10/59-02E 26021 Frederick Road
(Hyattstown Historic District)

SUBJECT: Historic Area Work Permit 286 916

HISTORIC PRESERVATION COMMISSION STAFF REPORT

Address:	26021 Frederick Road	Meeting Date:	09/25/02
Applicant:	Donald R. Burgess	Report Date:	09/18/02
Resource:	Hyattstown Historic District	Public Notice:	09/11/02
Review:	HAWP	Tax Credit:	No
Site Number:	10/59-02E	Staff:	Robin D. Ziek
PROPOSAL:	Landscape site work; extend existing rear porch and fully enclose for interior space; construct new rear porch.		
RECOMMEND:	Approve

Proposed 1/8" = 12"
1st FLOOR PLAN

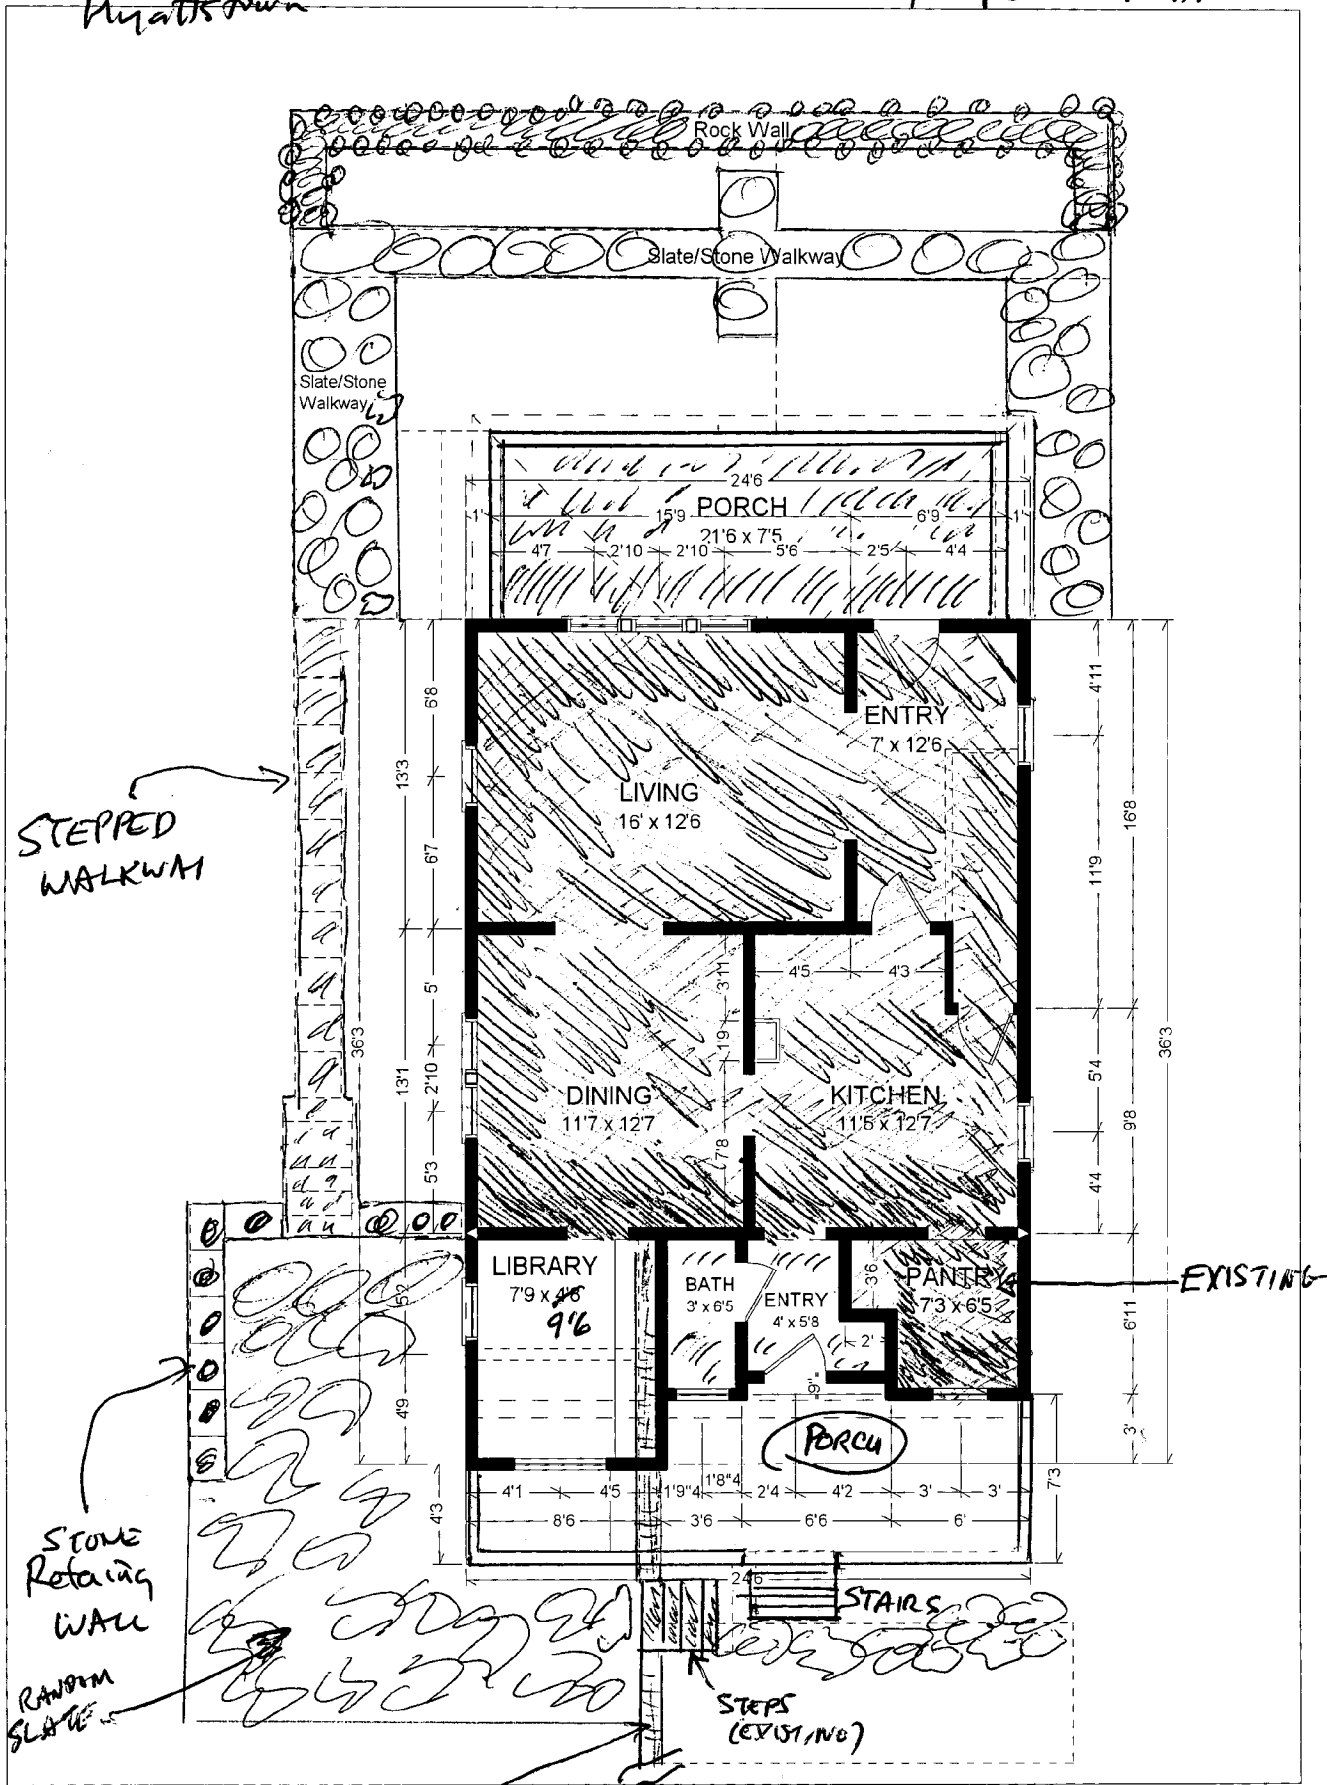
The applicant proposes to extend the existing rear porch across the full width of the house, and fully enclose this area (see Circle 14, 15, 20). The interior plan would be reworked to reflect the additional interior space. A new rear porch would be constructed across the full width of the back of the house, working within the confines of the existing block retaining wall and back steps (see Circle 15). All new material would match the existing materials. Existing windows would be incorporated into the new project, and an old window salvaged from another site would be used on the rear elevation.

The proposed work is compatible with the district. There are other stone retaining walls in the district, and slate was quarried locally. The rear addition is designed to preserve the existing massing. The enclosure of the one-story porch, and the addition of a new open porch is consistent with this historic resource, and preserves the original massing of the Four Square.
